Addendum No. 1 – Mexico Beach Pier

May 21, 2025

Project: Mexico Beach Pier – Non-mandatory Pre-Bid Minutes

B1 TYPICAL PIER SECTION BENTS 10 THRU 27
SCALE: 3/16" = 1'-0" 0 5' 10'

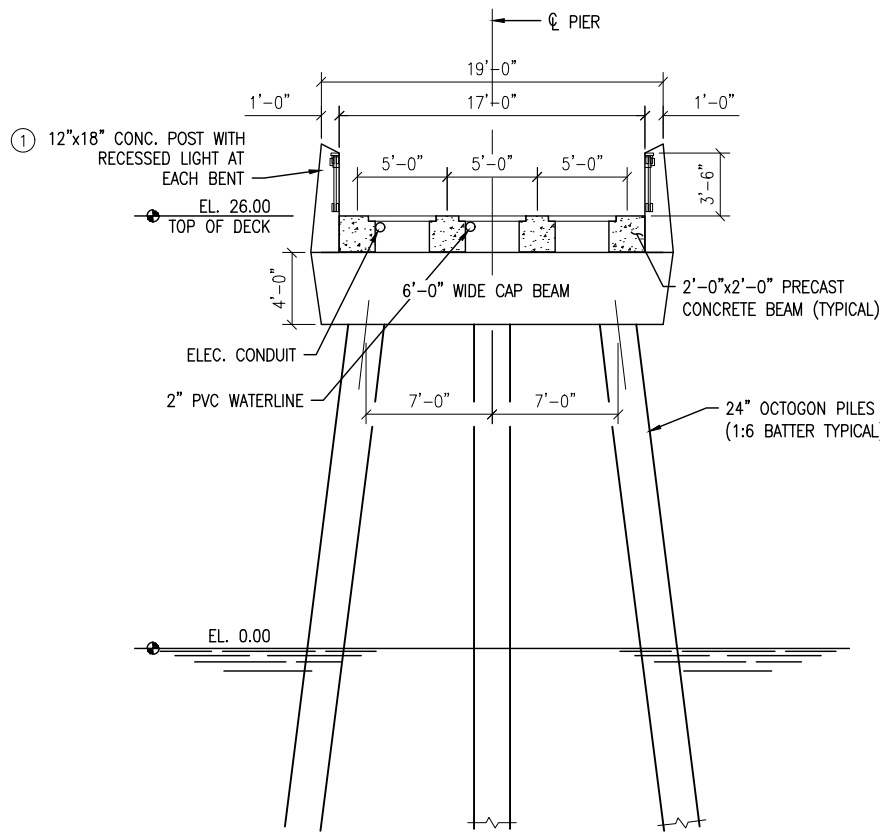
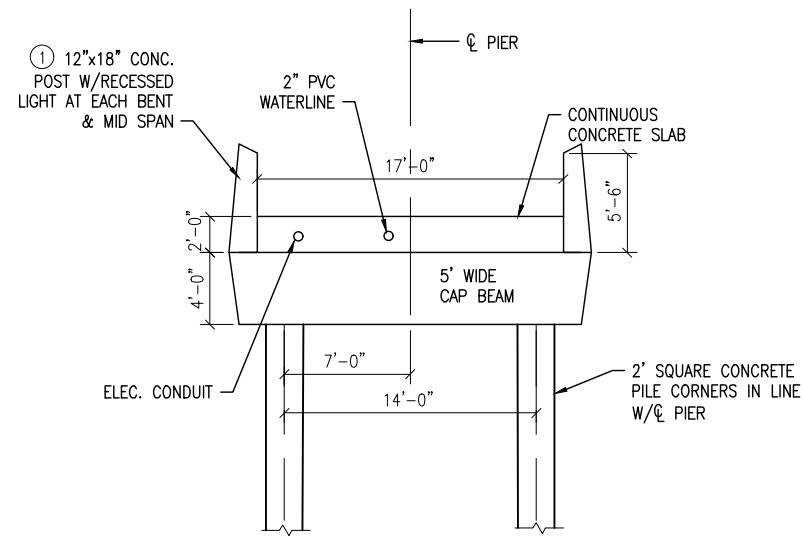
34. Sheet S102 detail B1 shows the concrete post to be 12” x 18” and detail A1 shows the post to be 12” x 20”. What is the correct size? *See the revised detail for the pile cap / pilaster connection detail on sheet A-01.*

40. Sheet S102 detail B1 shows 4 each concrete beams per typical span and sheet S103 pile layout plan says 3 beam section. Please clarify the quantity of beams per span.
4 beams per span

84. Please provide clarity on the Pilasters S-102 at each bent. Details B1 and D3 on S-102 indicate a 12"x18" concrete post. No reinforcing detail is provided for these. *Reinforcing details have been added to the Architectural drawings.*

OCTAGONAL PILE SECTION

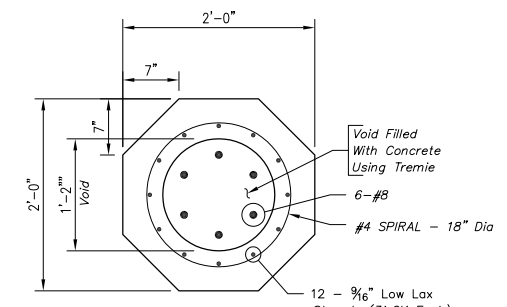
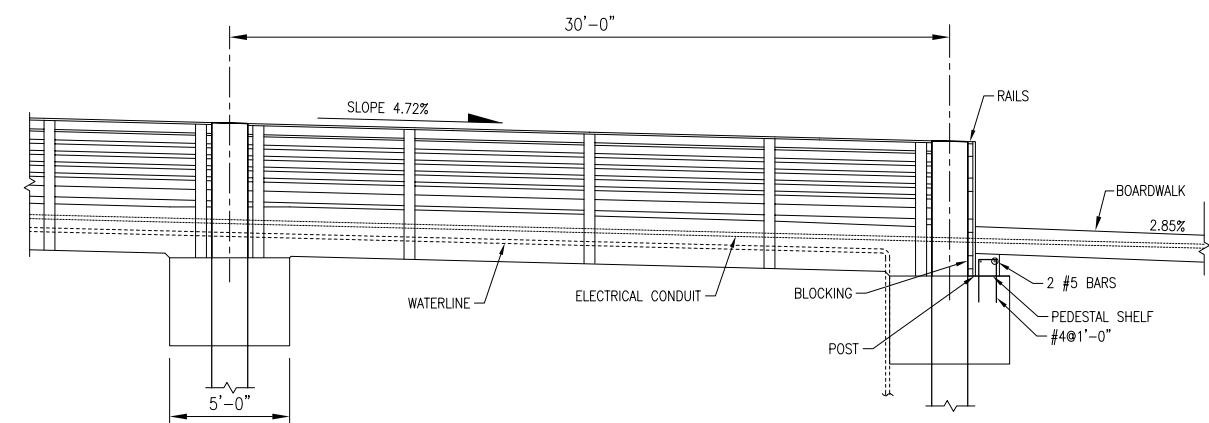
26. Are octangular piles required? *Yes. See the attached detail of the octangular piles section on S-104.*

32. Sheet S105 section A2 – Please provide section detail for octagon shaped piles
Attached on revised S-104
33. Sheet S105 – precast slab detail. According to the prestress manufacturer, they do not make ¼” diameter strand and 3/8” diameter strand will not work with a 3.5” concrete panel thickness. Please advise. *See the answer to No. 89*

83. Sheet S-105 detail A2 is drawn as a square pile but called out as an octagonal pile. Please provide a pile section for a 24" octagonal pile. See *revised sheet S-104, attached*.

A7 PLAN OF TYPICAL 4 BEAM SPAN
Scale: 1/8" = 1'-0"

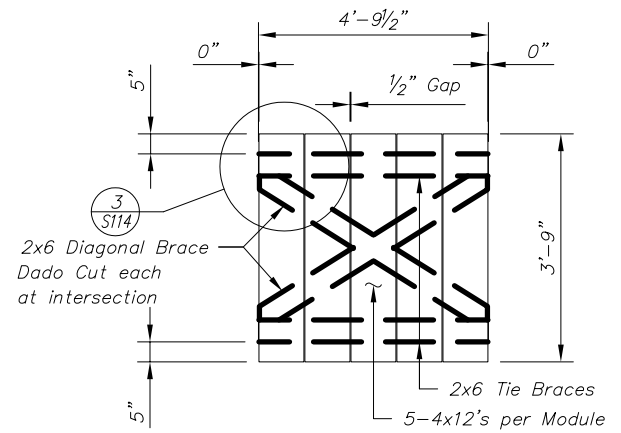
86. Sheet S-105, detail A7 depicts the pilasters setting directly on top of the cap, the architectural drawings depict the pilaster being cast into the outside face of the cap. The architectural details will add significant costs to the project. Please clarify. *The pilasters will sit on top of the beam. See Sheet A-01*

A5 ALTERNATE BID -DECKING MODULE
NOT TO SCALE

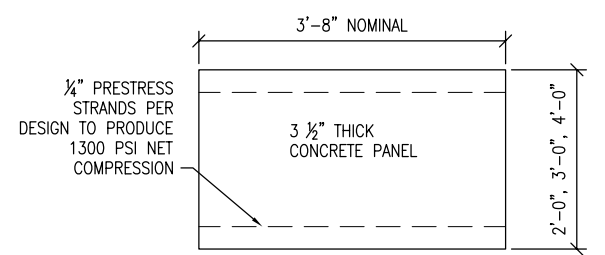
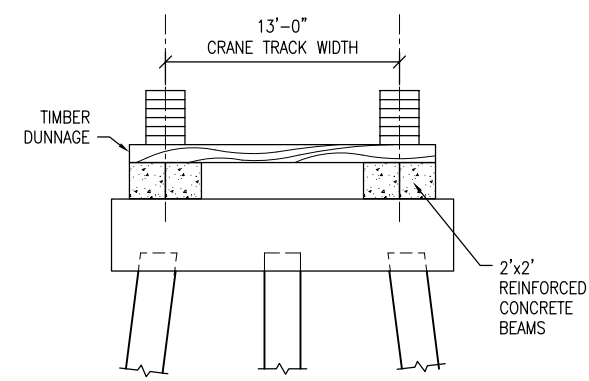
27. The concrete blowout panels show 1/8th inch strands, but these are not available for this application. The smallest is 3/8th inch. *A product called Lumbercon is available that uses 0.208" prestressing wires to fabricate a 3"x12" concrete plank. A corrosion resistant admixture can be added to the concrete mix and the ends of the planks can be sealed with epoxy. See also the answer at No. 89.*

89. Sheet S-105 detail A5 indicates an alternate decking module that is 3.5" thick with 1/4" strands. 3/8" is the smallest strand available. To accommodate this, a 5" deck panel would be needed. Would this be acceptable provided the ledger in the beam section was deepened to accommodate this deeper panel section? *Yes, adjusting the ledger is an acceptable alternative. In addition, see the following source for 3-inch concrete blowout panels:*

A - 01

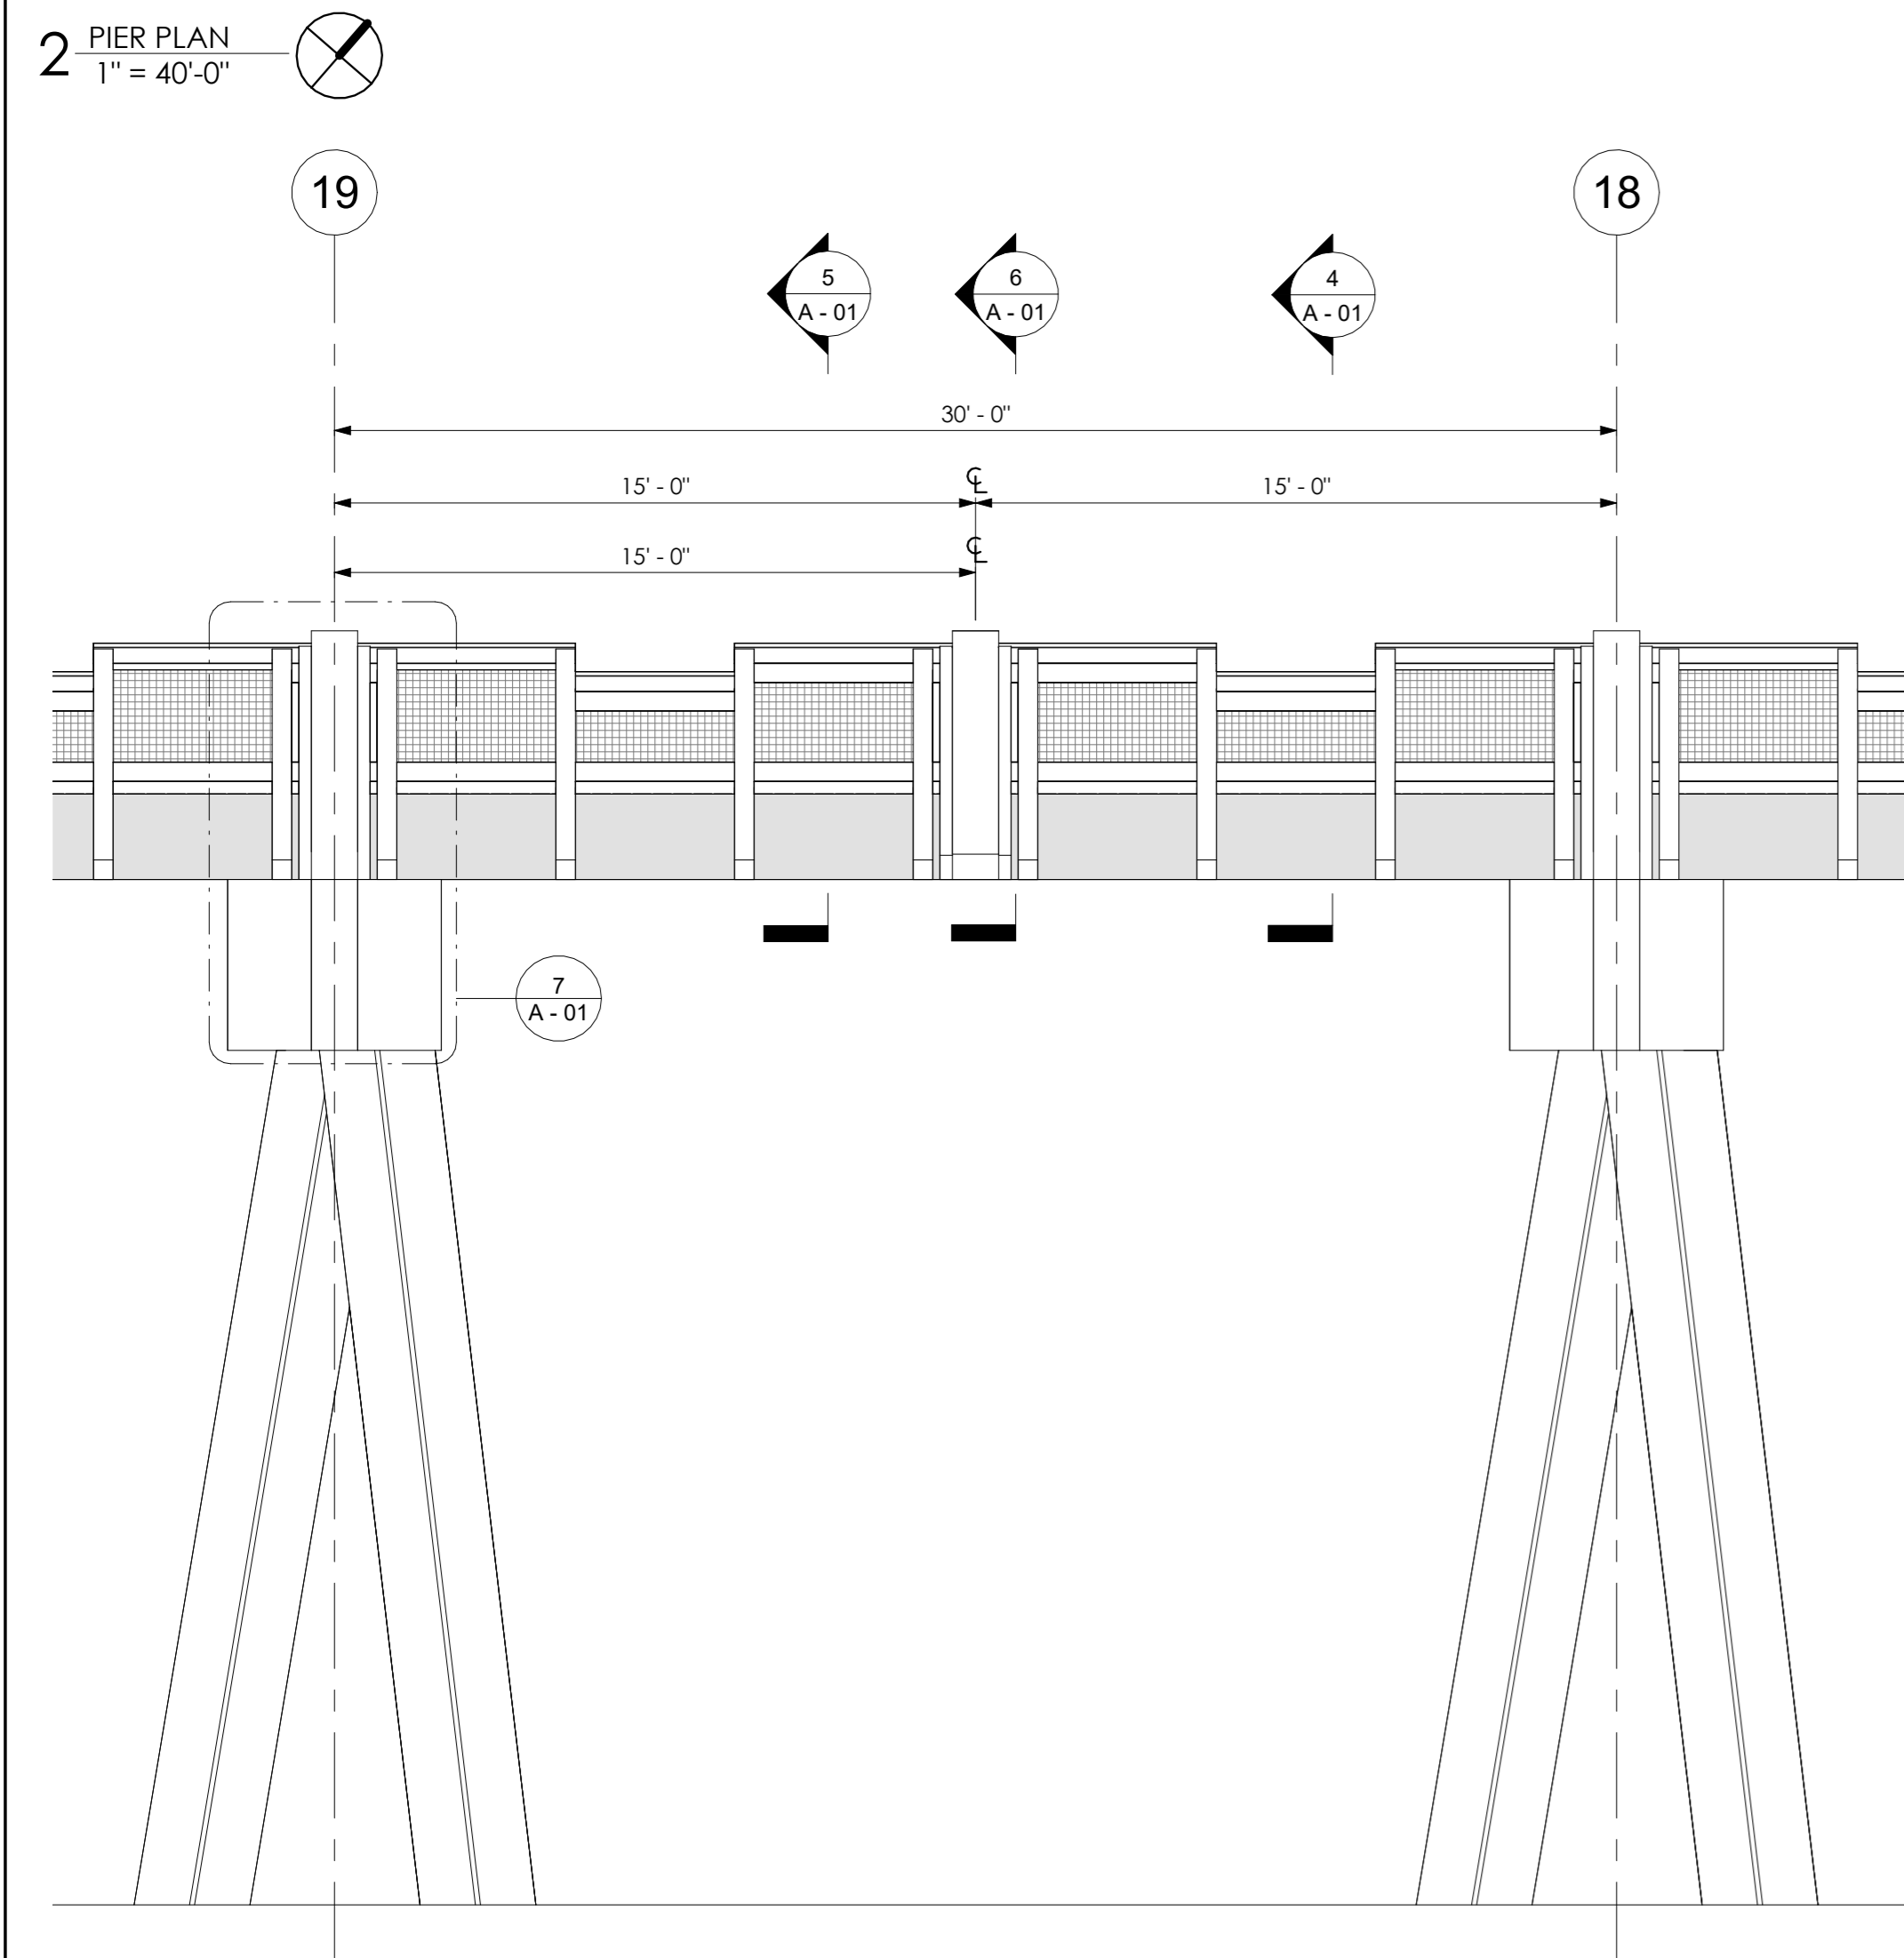
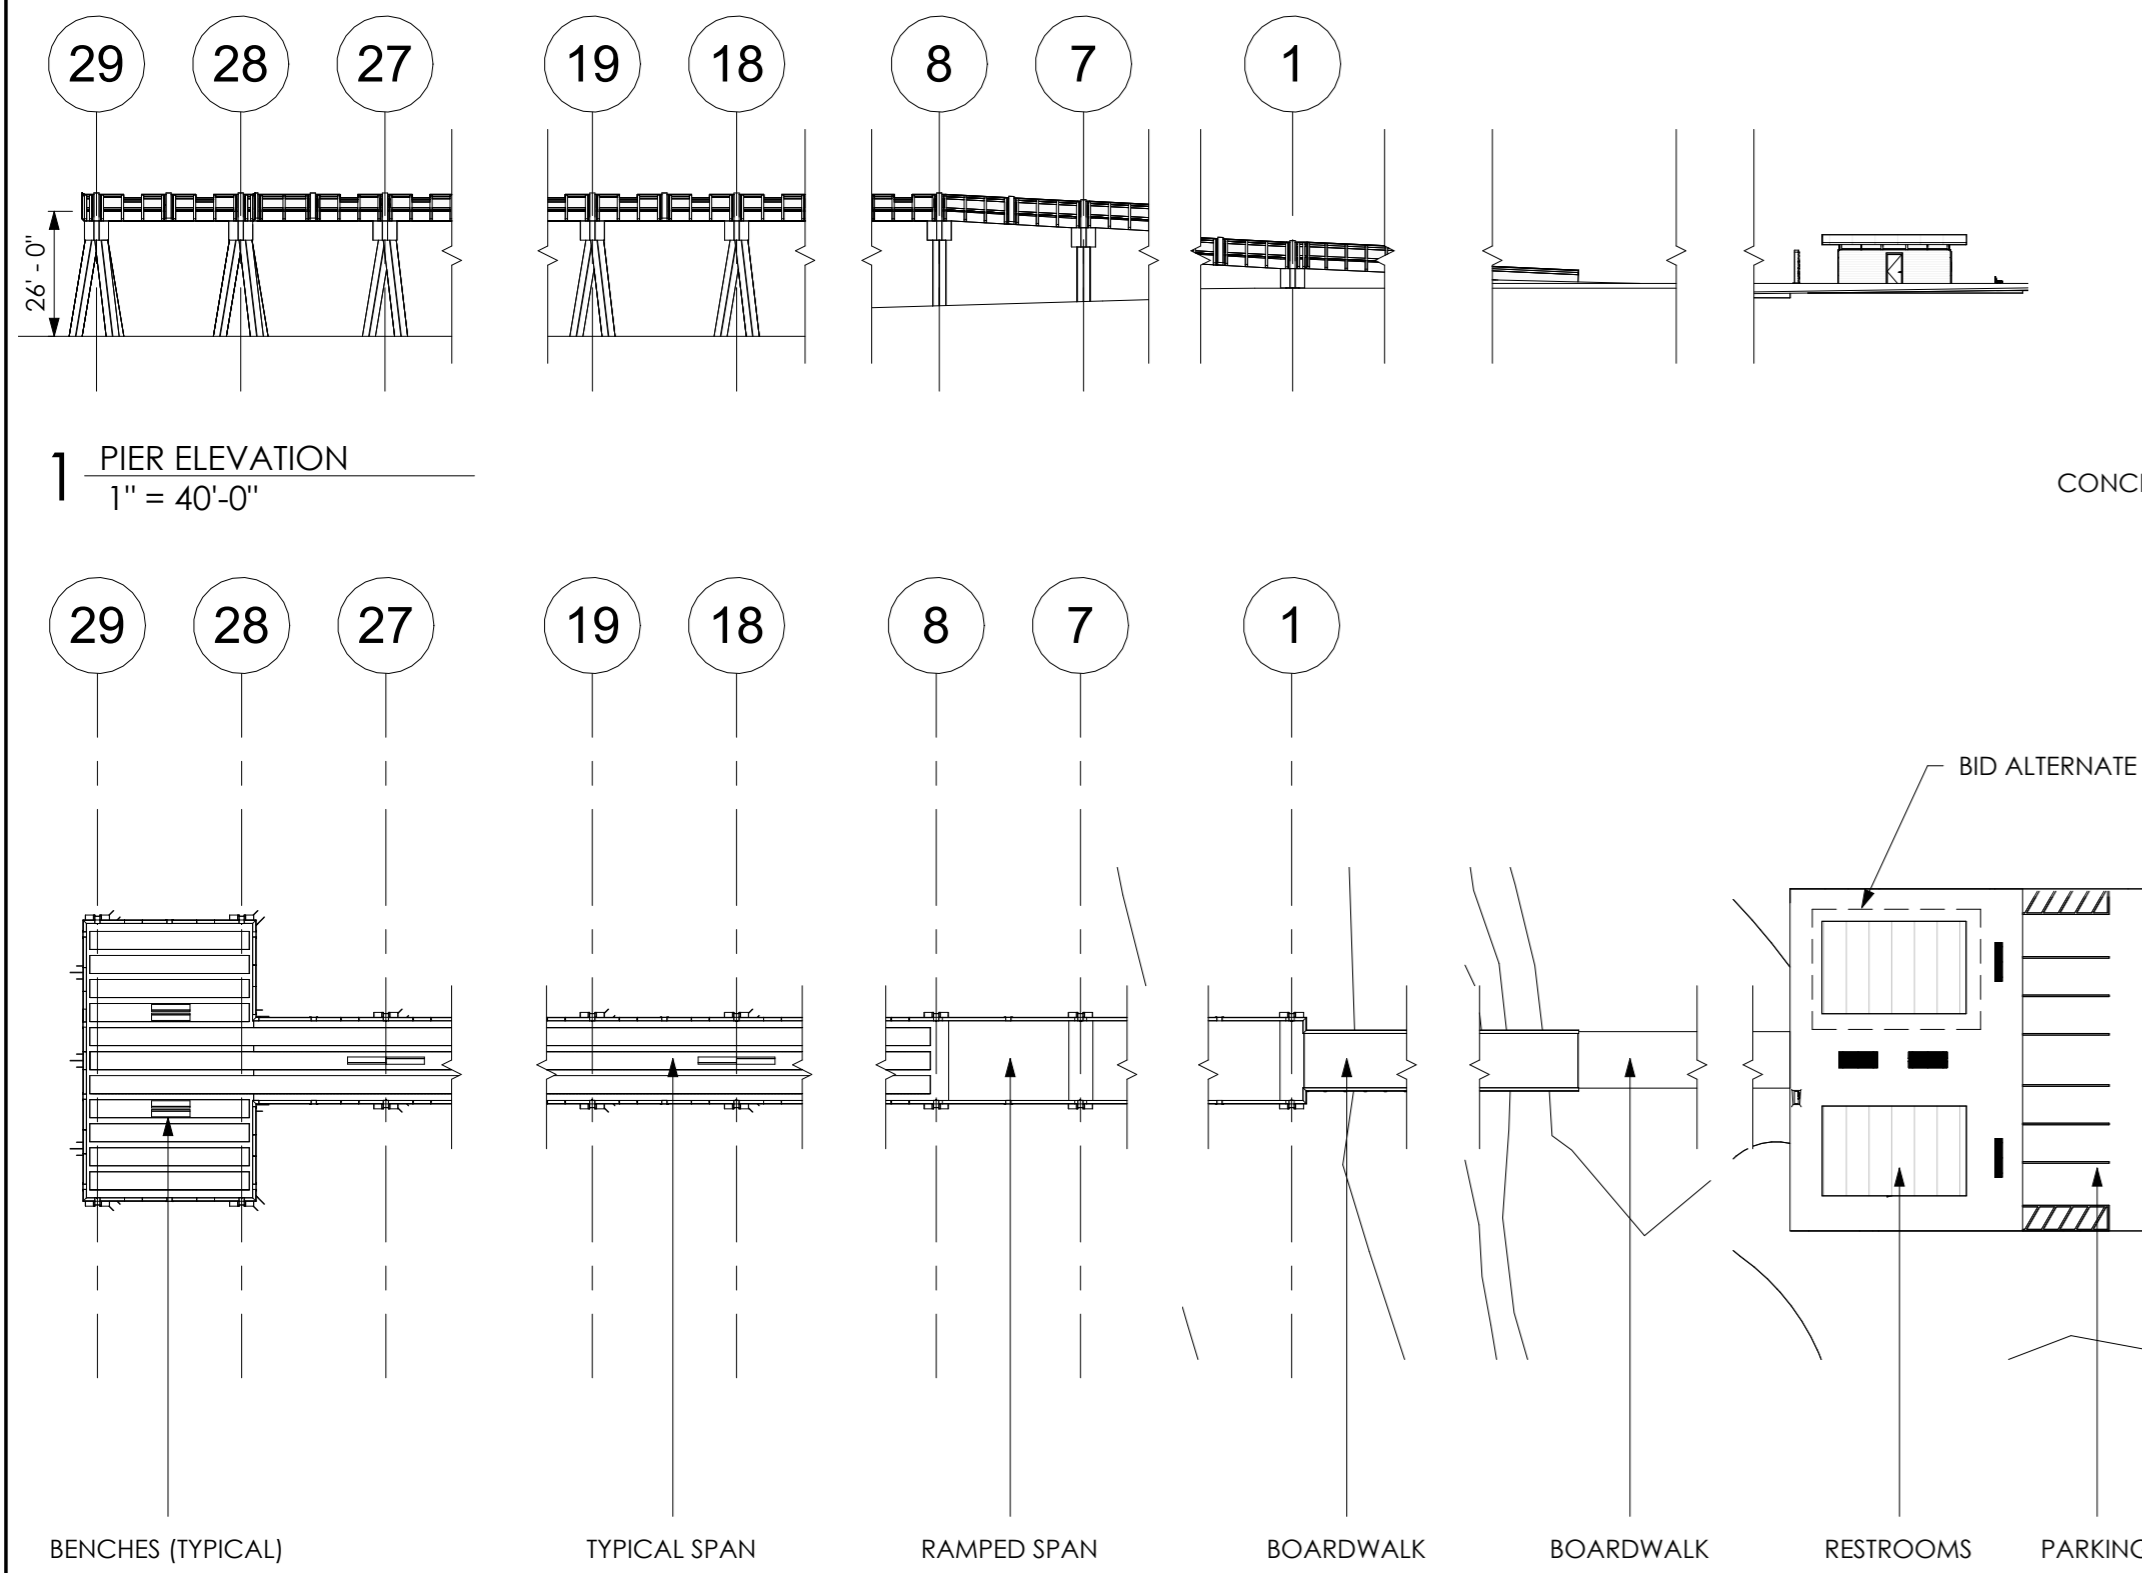
31. We see no detail on the pilasters incorporated into the guardrail? *See the revised detail for the pile cap / pilaster connection detail on sheet A-01.*

35. Please provide a detail on the concrete post. *See the revised detail for the pile cap / pilaster connection detail on sheet A-01.*
36. Please provide how the concrete post attaches to the concrete cap. *See the revised detail for the pile cap / pilaster connection detail on sheet A-01.*

67. Please provide reinforcing details for pilasters. *See A-01 for revised details.*

71. Please provide fastening/connection details for the timber handrail. *See A-01 for revised details.*
